10th November 2021

**RE: 131213/LO/2021 - Listed building consent for Internal and external alterations to facilitate the refurbishment of an existing restaurant.
Ground Floor Lloyds Bank Buildings 53 King Street Manchester M2 4LQ**

Plate 1: Approved Plan as per conditions imposed on Listed Building Consent 07451/LO/2014/C1

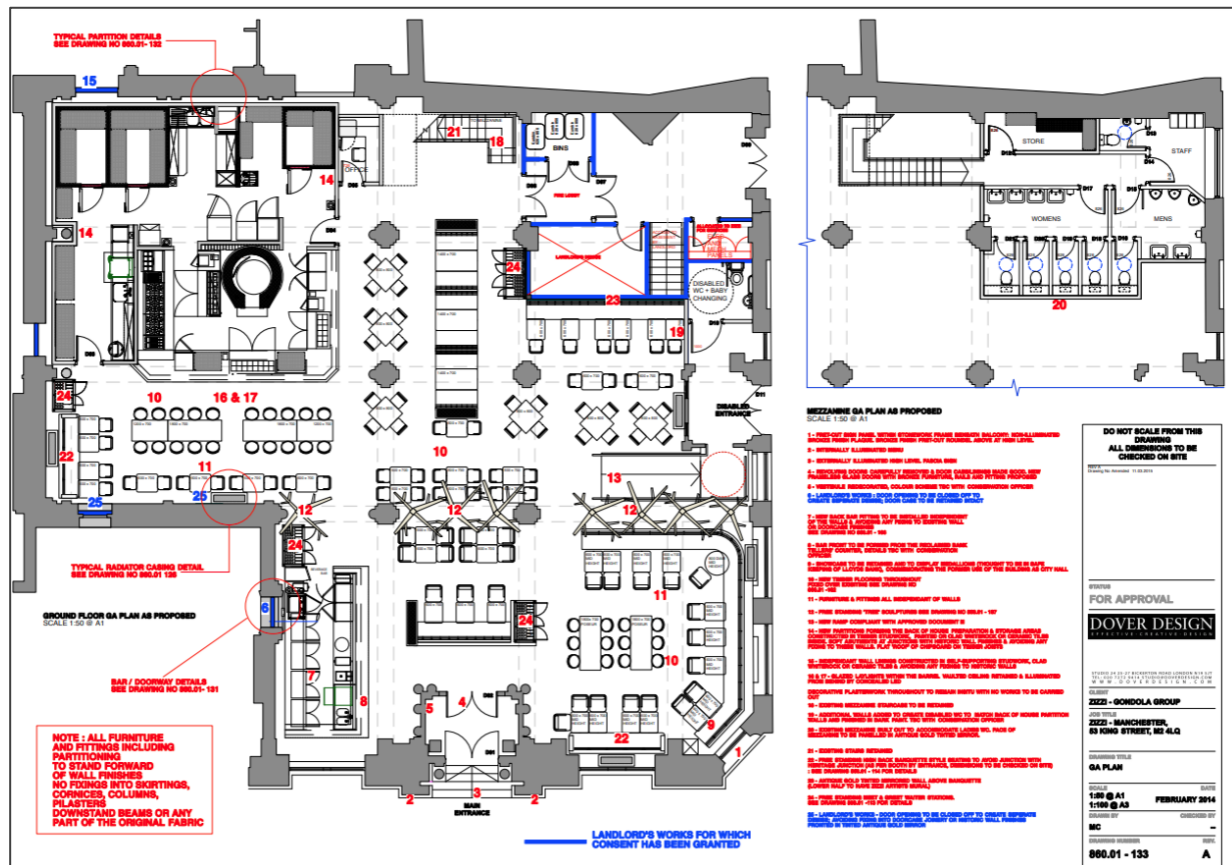
"The kitchen extension intrudes further into the space under the glazed vaulted roof. A kitchen in this highly significant space was only reluctantly accepted in the past in order to secure a new use for the building. It was only agreed based on its minimal footprint and minimised physical and visual intrusion in the space. The further encroachment under the current application is significant and harmful to the heritage asset. This element of the proposal requires further review to minimise the intervention."

- 7 We recognise that the kitchen area proposed is larger than that built out previously in 2014 for the Zizzi restaurant chain, but it is also noted that the approved plan (860.01-133 REV A GA Plan) as listed on the Decision Notice (ref: 07451/LO/2014/C1) shows a kitchen arrangement similar to that now being proposed (Plate 1). There appears to be some discrepancy between the approved plans listed in the Decision Notice and thereby it might be considered that a similar layout to that currently being proposed has been consented previously. However, we acknowledge that the layout built out by the previous tenant was not the layout shown on 860.01-133 REV A GA Plan. It is also noteworthy that the earlier applicants considered the kitchen layout should have been laid out as now proposed from an operational perspective.

- 12 The proposed kitchen extension is effectively one additional wall and a ceiling and continues at the height of the existing consented modern partition walls within the space (Plate 3). Neither the new wall or ceiling affixes to the marble lined walls or the barrel-vaulted ceiling, and the design ensures that the marble column and capital remain exposed. Neither the proposed wall or ceiling impinge on the ability to view and appreciate the barrel-vaulted ceiling with the only notable change from the previous layout being the inability to access part of the floor (approx. 15m²) directly from the public areas and view a small area of the marble wall or to look directly up at the vaulted ceiling from within this space.

- 13 When the proposal is considered alongside the previously consented layout which allowed for an open kitchen that severed more significant longer sight line across the internal space to the marble walls due to its height, the proposals here cannot be considered as being any more harmful (Plate 4). It is considered that the existing view of the wall and vaulted ceiling from within this 15m² area does not contribute significantly to the understanding of the special architectural or historic interest of the building as a whole.

Plate 6: Ground floor plan as originally built showing public and staff areas and how the space has changed.

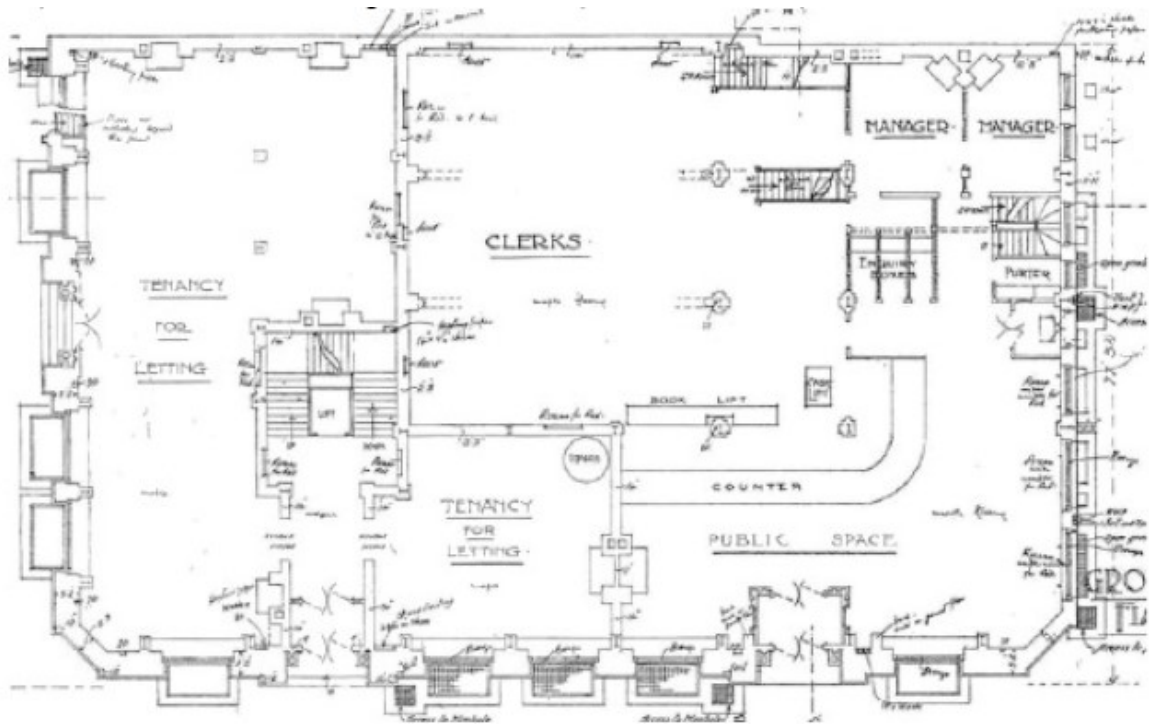
"The CGIs show a new back to the bar which is open to allow views to the panelling behind, which is acceptable. However, the plans and drawings show a finish to the back which would hide the original material. Please can the plans be clarified to show that the panelling behind will remain in view."

23 The marble behind the bar area is not entirely original marble with part of the wall being covered with fake marble from where the former connecting doorway has been infilled, see Plate 6 and Plate 7 in appendix. It does not contribute to the special interest of the interior, and it is not desirable to see this fake marble in any view behind the bar.
